REDSTONE GATEWAY PACKAGE I – LAKE F
Project No. 65-12-SP23
July 9, 2012

Addendum #3

C4.0

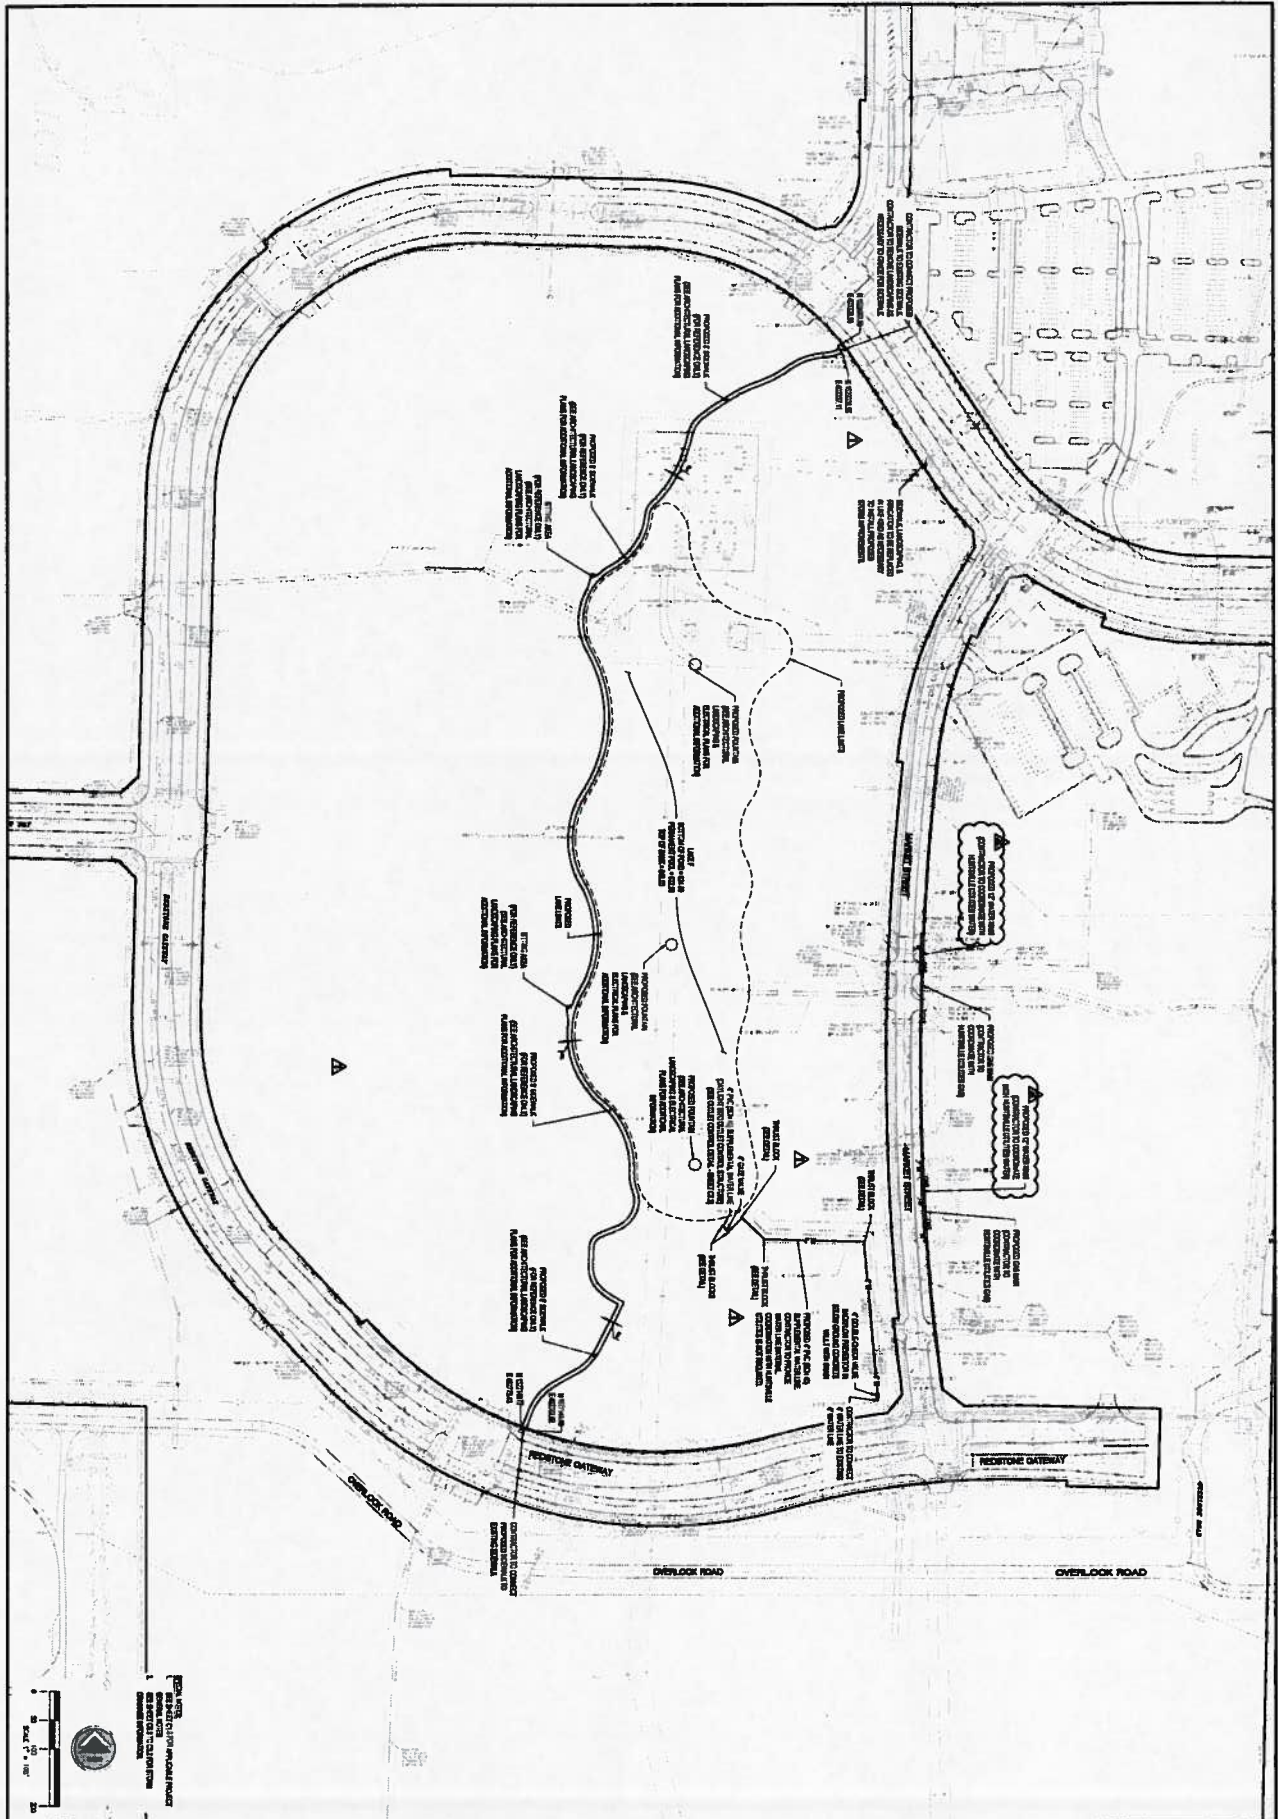
14. Q. Note on sheet C 4.0 says to tie 4" water into 4" conduit. Is this correct?
A. Contractor shall tie to existing 4" water stub.
15. Q. What other utilities other than the 4" water, the 8" ductile iron stub out, and raising the existing fire hydrant, is to be included in our price?

29. Q. On Sheet C4.0, there are two mains listed at the top of the page (Proposed 8" Water Main and Proposed Gas Main), is the contractor responsible for installing this? Or is the City of Huntsville responsible for installing this? If the contractor is responsible, what are the sizes and materials of the Proposed Gas Main and Proposed 8" Water Main?

A. See Sheet C4.0 issued in Addendum #3 for the revised scope of work. The 8" water stub out on the North end of the site and raising the fire hydrant on the South end of the site have been deleted from this scope of work. The water line relocation work along Market Street has been changed to a 12" water main and the materials must be purchased from Huntsville Utilities. Please note the Package I-1 Contractor must include the cost of the ATC for the water main in their lump sum bid. The ATC cost for the water main work will be issued in Addendum #4.

- A. Per Addendum #3 Sheet C4.0 the Package I-1 Contractor must install the 12" water line and the materials will be provided by Huntsville Utilities. Please note the Package I-1 Contractor must include the cost of the ATC for the water main in their lump sum bid. The ATC cost for the water main work will be issued in Addendum #4. The gas line will be installed by Huntsville Utilities.

A. Yes; Addendum #3 revised Sheet C4.0.
